Planning Application for
“Temporary Storage of Construction Materials with Ancillary Site Office and
Associated Filling of Land” for a Period of Three Years
Lots 469s.ARP(Part) and 469s.BRP(Part) in D.D. 110 and adjoining Government Land
Pat Heung, Yuen Long, New Territories
(Planning Application No. A/YL-PH/1104)

Subject: Application for Certificate of Exemption of Drainage Work
LOT NOS. 469S.ARP(PART) AND 469S.BRP(PART) IN D.D. 110
AND ADJOINING GOVERNMENT LAND, PAT HEUNG, YUEN LONG NT

PROPOSED DRAINAGE WORK ON

LOT NOS. 469S.ARP(PART) AND 469S.BRP(PART) IN D.D. 110
AND ADJOINING GOVERNMENT LAND, PAT HEUNG, YUEN LONG NT

BLOCK PLAN 1:1000

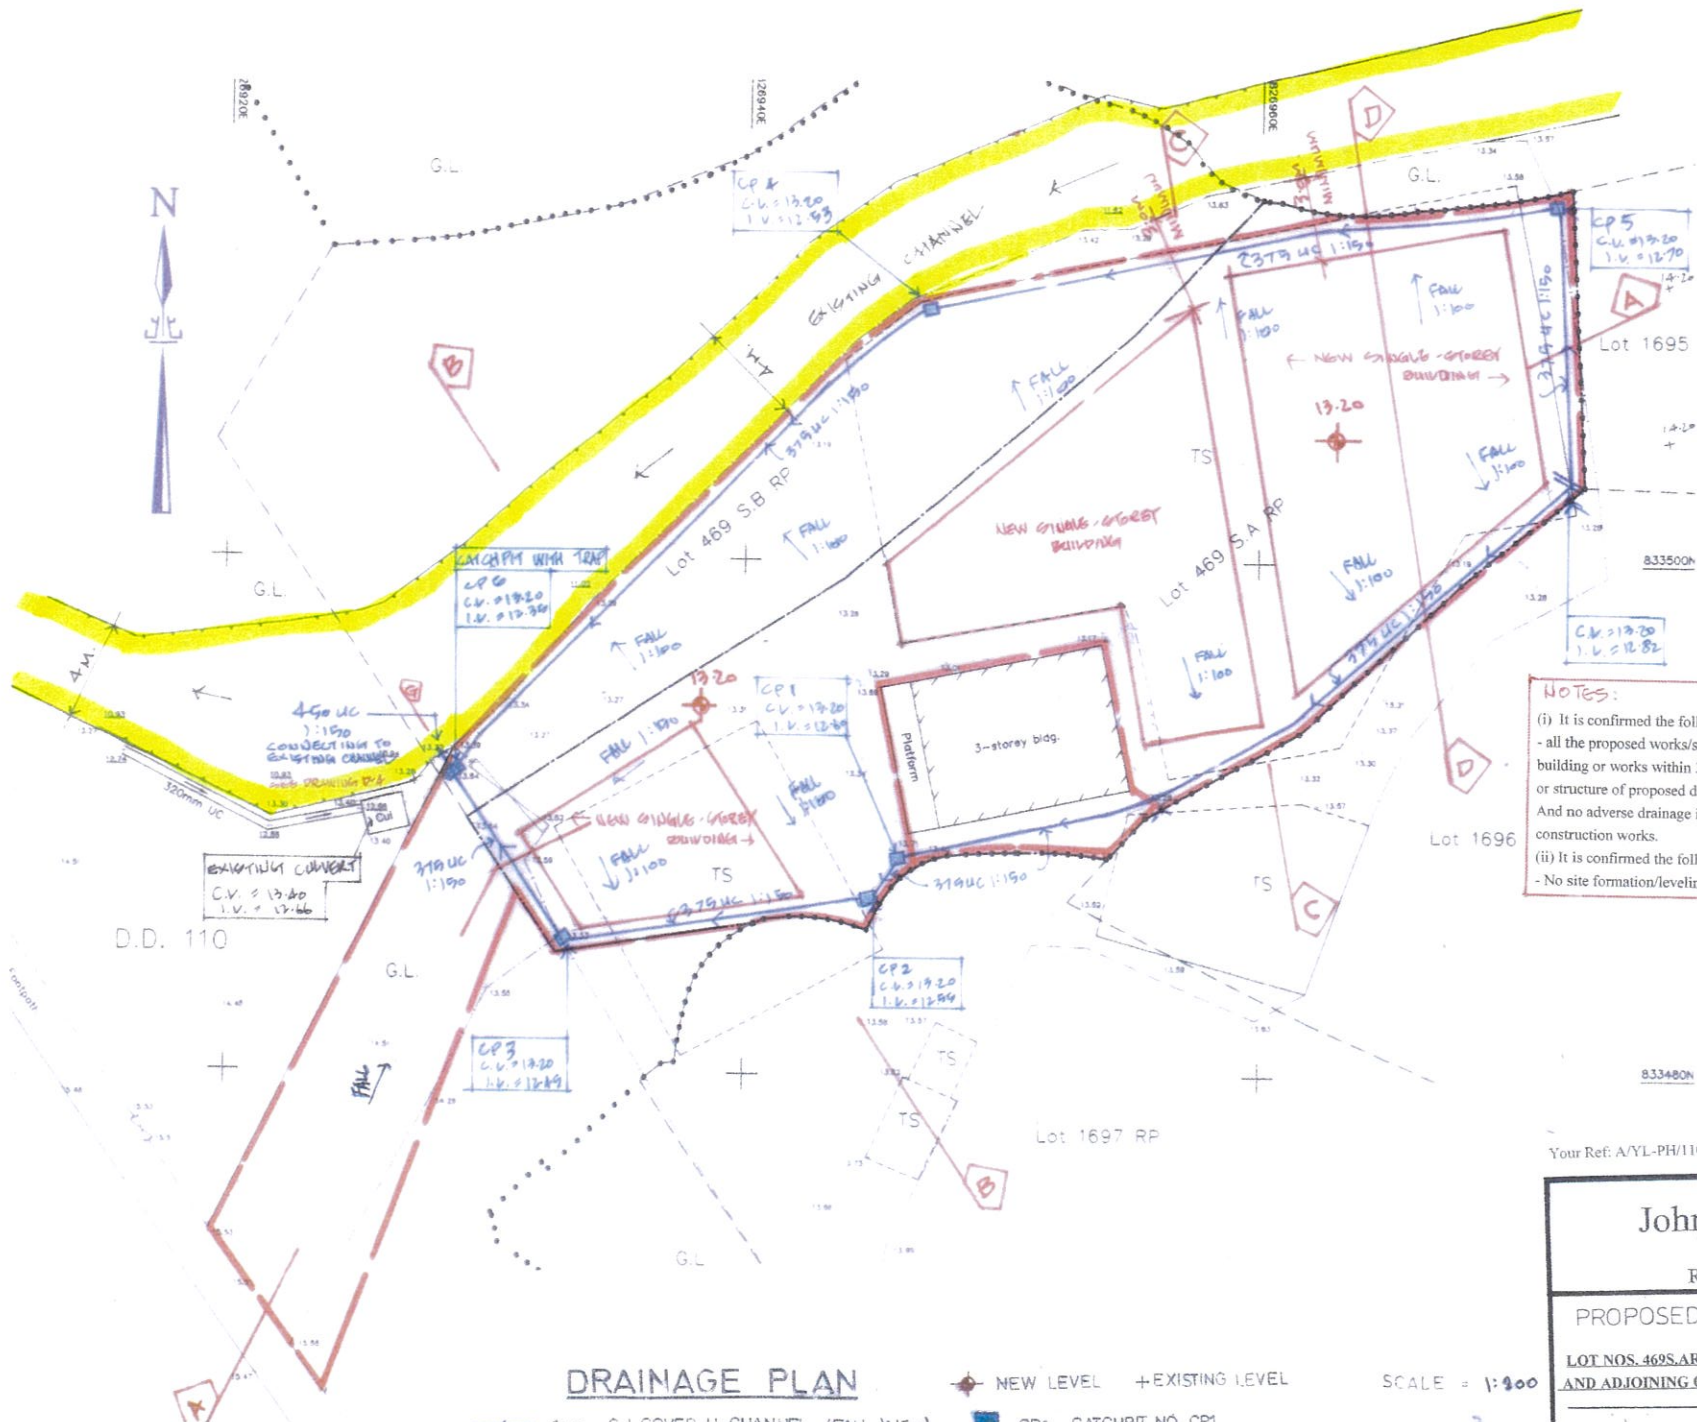
(i) It is confirmed the following statement by lot owner.

- all the proposed works/structure will be placed 3m away from the top of bank (and all existing building or works within 3m from top of bank to be demolished if any); and no any foundation or structure of proposed development loading imposed onto this existing channel.
- And no adverse drainage impact to be created to this existing channel during and after construction works.

(ii) It is confirmed the following statement by lot owner.

- No site formation/leveling works to be carried out under this application.

DETAIL OF HOARDING OPENING 1:75

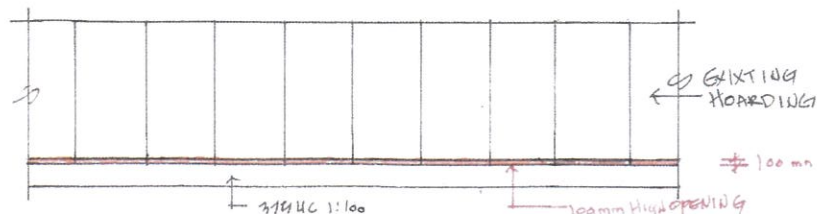
- (ii) It is confirmed the following statement by lot owner.
 - No site formation/leveling works to be carried out under this application.
- (iii) A gap at toe of proposed hoarding is to be carried out (about 100mm) as shown on the revised drawings.

PHOTO PLAN

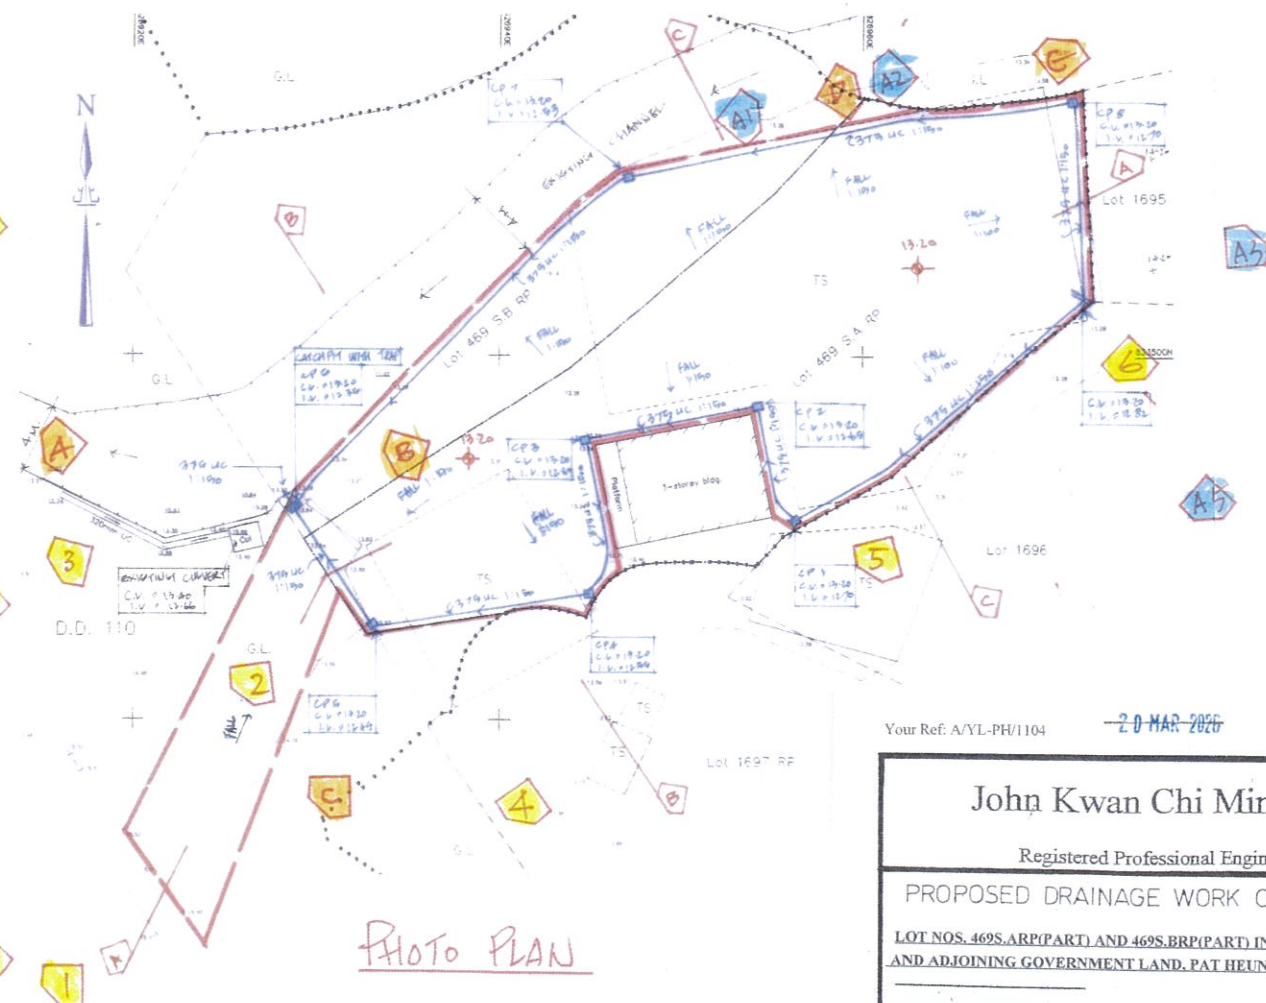
- (v) Noted, photos shown on drawing.
- (vi) Noted, no adverse effect to the adjacent land and or existing streams etc.
- (vii) Noted, it is to be carried out by lot owner if any.
